Curiosity Nano Explorer Errata

Curiosity Nano Explorer Errata [EV58G97A]

Revision history and errata for all revisions of Curiosity Nano Explorer (EV58G97A).

Figure 2-1. SDCARD Silkscreen

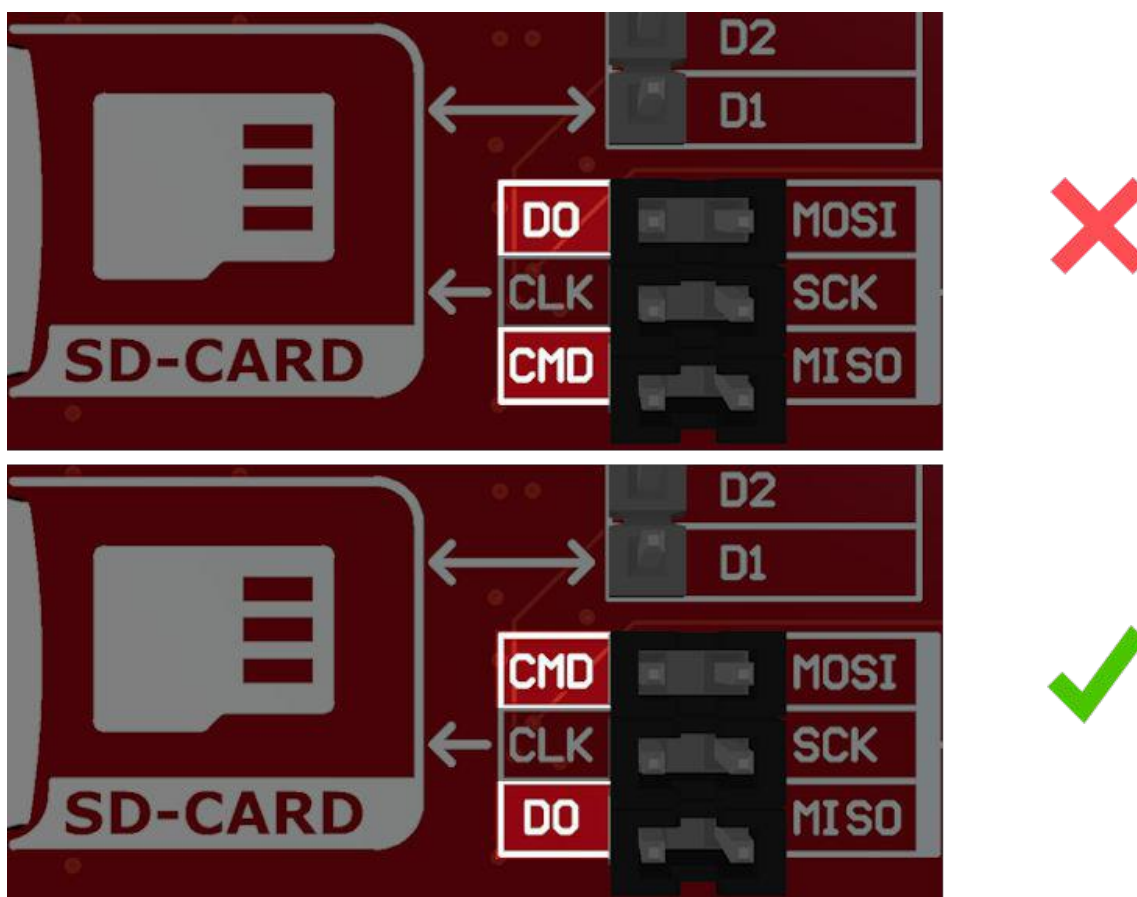
Marking of D0 and CMD in the silkscreen is swapped compared to the electrical connection in the PCB. The connections to the microcontroller are correct to communicate with an SDCARD.

- X The D0 and CMD silkscreen location is swapped compared to the electrical connection
- ✓ The D0 and CMD silkscreen location matches the electrical connection

None.

Figure 2-2. Power Monitor Silkscreen

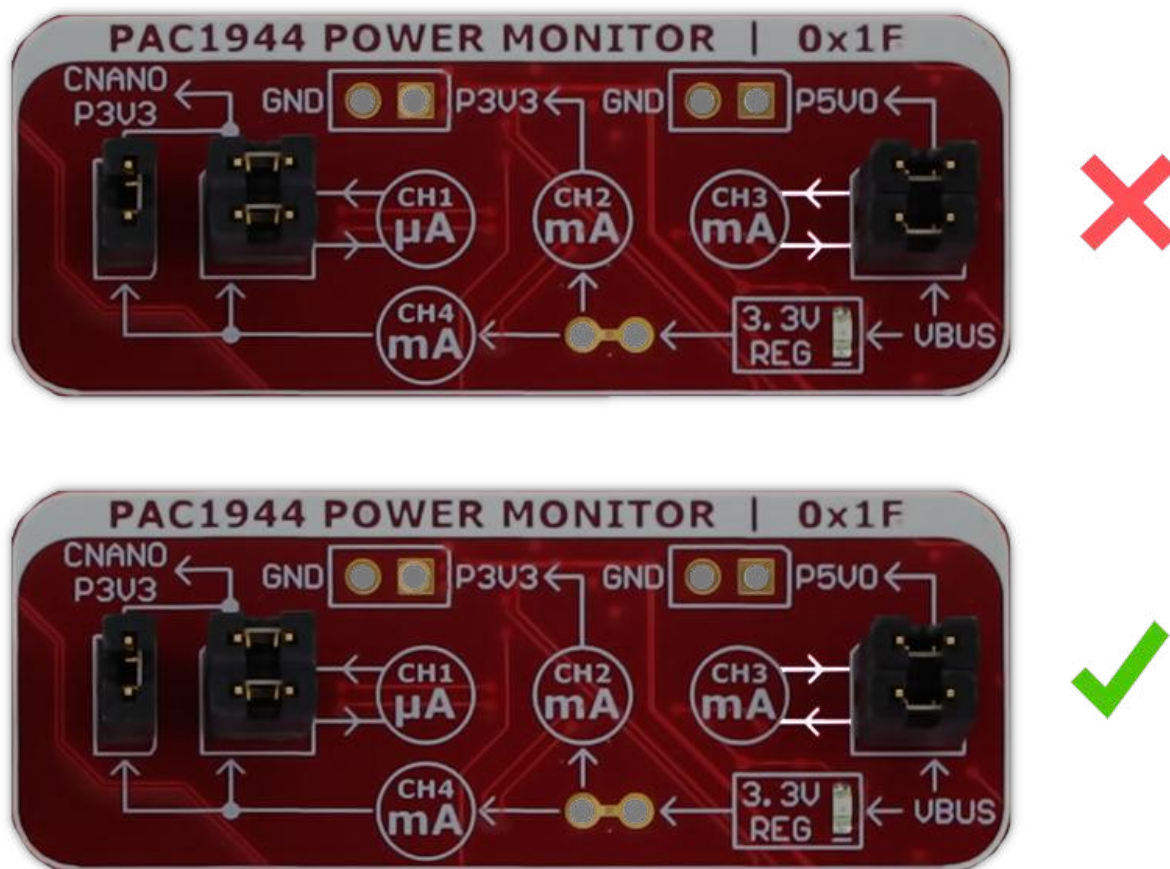
Arrows are drawn in the silkscreen to indicate the current flow in the PAC1944 power monitor section of the board. The arrows indicating the current flow through channel 3 point in the wrong direction.

- X Silkscreen arrows point in the opposite direction of the current flow through channel 3
- ✓ Silkscreen arrows point in the same direction as the current flow through channel 3

None
